DEVELOPMENT REVIEW BOARD REPORT

CASE NUMBER/ 17-DR-2005

Site 10 Booster Pump Station

REQUEST Request approval of site plan and elevations for construction of a new City

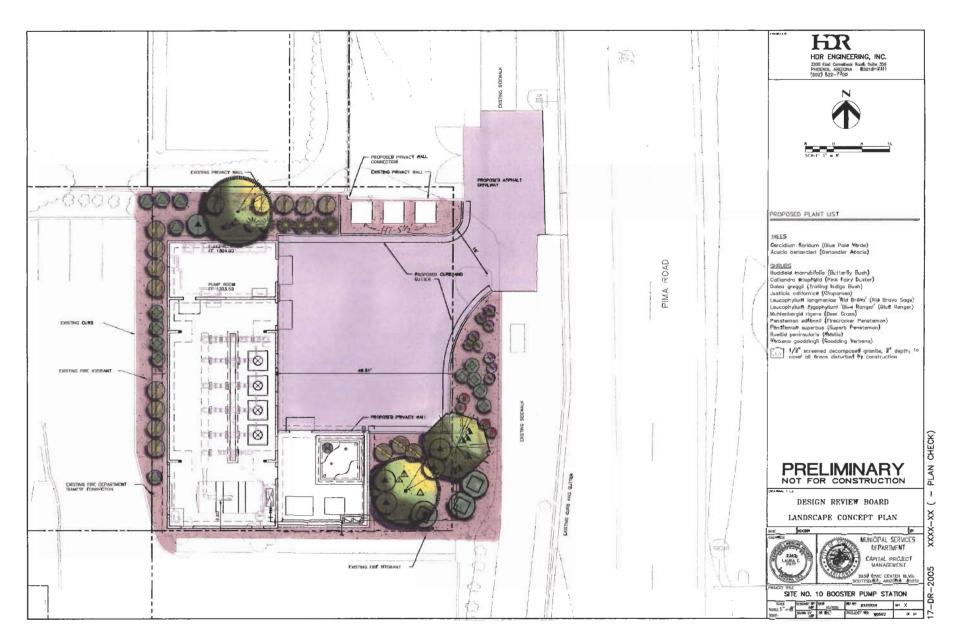
10. The applicant shall extend the Pima Road Screen wall, that ends at the north property line, south and west. The alignment of the wall shall follow the driveway entrance curb line south and west into the site. The wall shall end west of the middle transformer.
